ZONING AMENDMENT,
PLANNED UNIT DEVELOPMENT &
SUBDIVISION STAFF REPORT

Date: April 21, 2005

<u>NAME</u>	NTG-C Investments
<u>DEVELOPMENT NAME</u>	Westwood-Airport Subdivision, Addition to
<u>LOCATION</u>	Rezoning: 2200 Airport Boulevard (Northwest corner of Airport Boulevard and Crenshaw Street) Planned Unit Development & Subdivision: North side of Airport Boulevard, extending from Crenshaw Street to Westwood Street
<u>CITY COUNCIL DISTRICT</u>	District 5
<u>PRESENT ZONING</u>	B-1, Buffer-Business
<u>PROPOSED ZONING</u>	B-2, Neighborhood Business
<u>AREA OF PROPERTY</u>	1± Acre
<u>CONTEMPLATED USE</u>	Multiple buildings on a single building site for expansion of an existing retail shopping center. It should be noted, however, that any use permitted in the proposed district would be allowed at this location if the zoning is changed. Furthermore, the Planning Commission may consider zoning classifications other than that sought by the applicant for this property.
<u>TIME SCHEDULE FOR DEVELOPMENT</u>	Upon approval

SITE PLAN

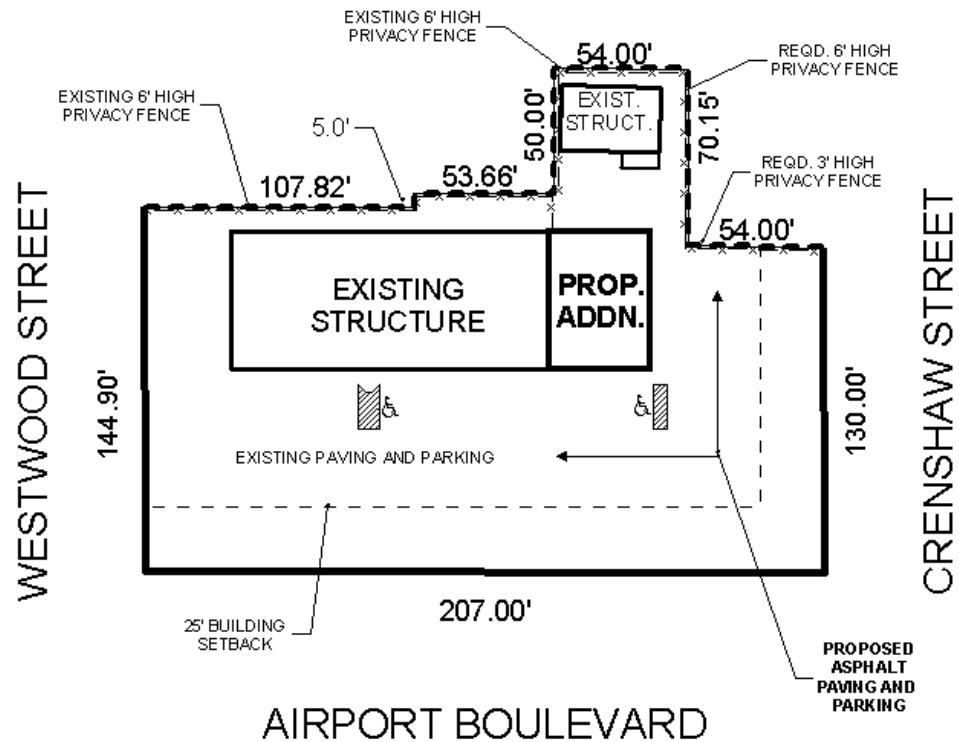
The purpose of the PUD application is to allow the existing garage to remain on the site (at the northeast corner). At this time, no use or occupancy is proposed for the garage; however, it should be noted that any proposed commercial occupancy for this structure would require verification of parking, as well as permit(s). It should also be noted that the existing development is in compliance with the landscaping and tree planting requirements of the Ordinance; however, the additional property must comply with the landscaping and tree planting requirements as well, and with the exception of frontage trees, these requirements maybe distributed along the overall site.

The subdivision application would combine multiple lots into one lot, and with the placement of a note on the final plat stating that the site is limited to one curb cut to Airport Boulevard, the plat will meet the minimum requirements of the Subdivision Regulations.

Subdivision The plat meets the minimum requirements of the Subdivision Regulations and is recommended for Tentative Approval subject to the following condition: 1) placement of a note on the final plat stating that the site is limited to one curb cut to Airport Boulevard, with the size, location and design to be approved by Traffic Engineering.
